1968 Corvette: Service Bulletin: Cracking of the Plenum at the Right Hood Latch Plate

Bulletin No: 68-T-68

Date: Nov. 11, 1968

RIGHT HOOD LATCH REINFORCEMENT PLATE INSTALLATION 1968 CORVETTE

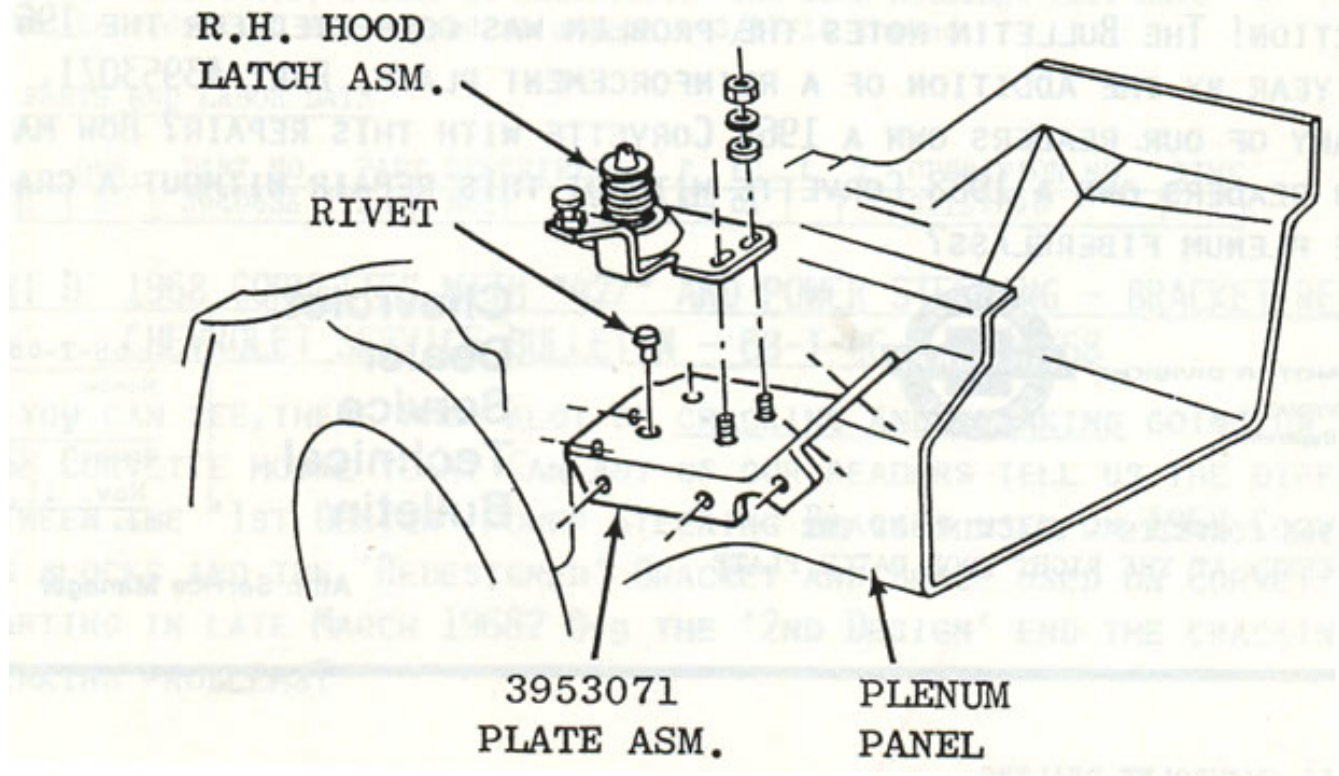
Cracking of the fiber glass plenum in the area of the right hood latch may be experienced on some 1968 Corvettes. This cracking is due to the manufacturing process of the plenum causing a glass rich condition in this area. This condition was corrected at the start of the 1969 production by the addition of a reinforcement plate to the area.

Whenever this cracking condition is encountered in the field, it may be corrected by riveting a reinforcement plate Part No. 3953071 to the outer surface of the plenum as outlined under Service Procedure.

1. Remove right hood latch assembly from the plenum panel and remove cowl vent grille.
2. Drill out two rivets retaining existing stud plate to plenum using a 7/32" dia. drill bit. Remove stud plate through cowl vent opening.
3. Position reinforcement plate on plenum as shown in sketch and drill seven (7) holes 7/32" dia. at hole locations in plate. The two (2) outboard holes are not accessible for drilling.
4. Attach the reinforcement plate to the plenum using 3/16" x 5/8" "Pop" Rivets.
5. Install and adjust right hood latch assembly as outlined in the August 1968 issue of "Chevrolet Service News." Install cowl vent grille.
